**NOTICE OF MEETING**  
**PLANNING AND ZONING COMMISSION**  
**6:00 P.M. – February 16<sup>th</sup>, 2023**  
30360 Cougar Bend, Bulverde, TX 78163

PLANNING AND ZONING COMMISSION ITEM:  
PC-22-30  
**FINAL PLAT**  
Heimer Cove

Halff Associates, on behalf of the City of Bulverde, has performed a review on the final plat (dated November 2022) and revised supporting documents for the **Johnson Ranch South, Star Gazer Road** development. The review was conducted relative to the requirements established in the vested Subdivision Ordinance 258-07-09-25 (with amendments through April 11, 2011) of the City of Bulverde AND the Development Agreement dated September 11, 2012.

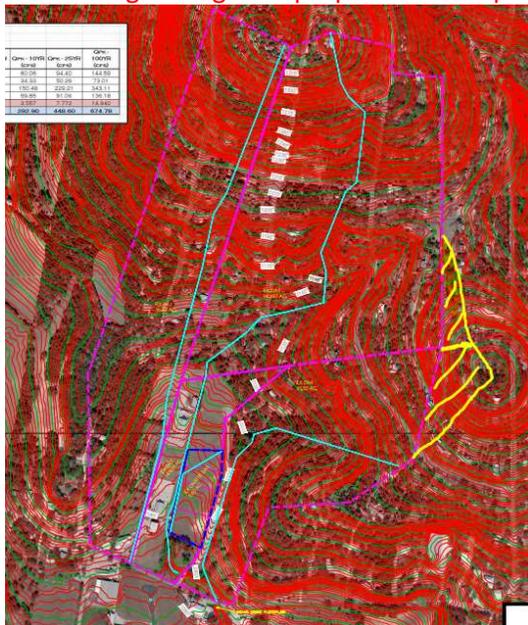
19. The on-site area should be evaluated with the overall watershed at the point where runoff leaves the site. There is a history of flooding at the adjacent downstream office building, so it is not acceptable to simply state that “downstream criterion are not applicable.”

*The provided 100-Year Ultimate Water Surface exhibit (last page of the drainage study PDF) uses a 100-year flow that is not supported anywhere in the drainage study. Provide a unit hydrograph study showing that there are no adverse impacts at the downstream property line as a result of the proposed development. Detention is required unless it is proven to have an adverse impact (BDDM Section 7). If Hec-RAS or HEC-HMS are used, provide digital copies of the models. **Comment resolved.***

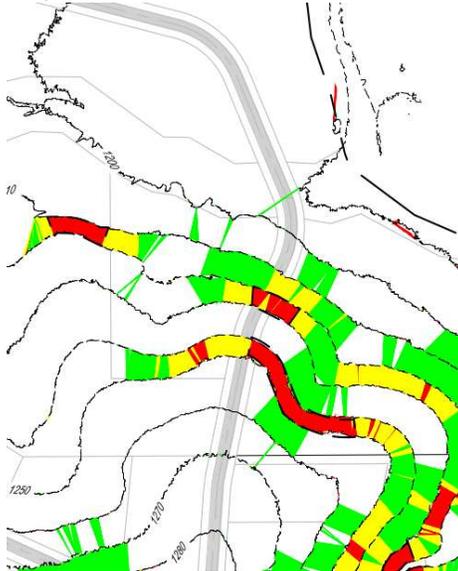
14. Drainage area EX1.1 needs to be broken up to look at the runoff coming directly through and off of the subject development, and not lump it in with the larger overall watershed looking at a downstream point, and allow for a more direct comparison with proposed conditions that includes detention ponds. – [Comment resolved.](#)

15. Curve Number calculations should include the area in acres (not just percentage) for each land use type. Fair Woods and Farmsteads are not uses identified in the BDDM, and curve numbers for these areas need to be updated for all CN calculations. – *Response references TR-55. Fair Woods/Grass combination is more inline with an orchard or tree farm. The existing area to be developed is more closely representative of Good Woods (Woods are protected from grazing, and litter and brush adequately cover the soil) with a CN of 77 for D soil, which is also provided on Table 4.1 of the BDDM. This also coincides with the manning’s n value chosen for sheet flow.* - [Half agrees with the assessment based on additional information submitted – resolved.](#)
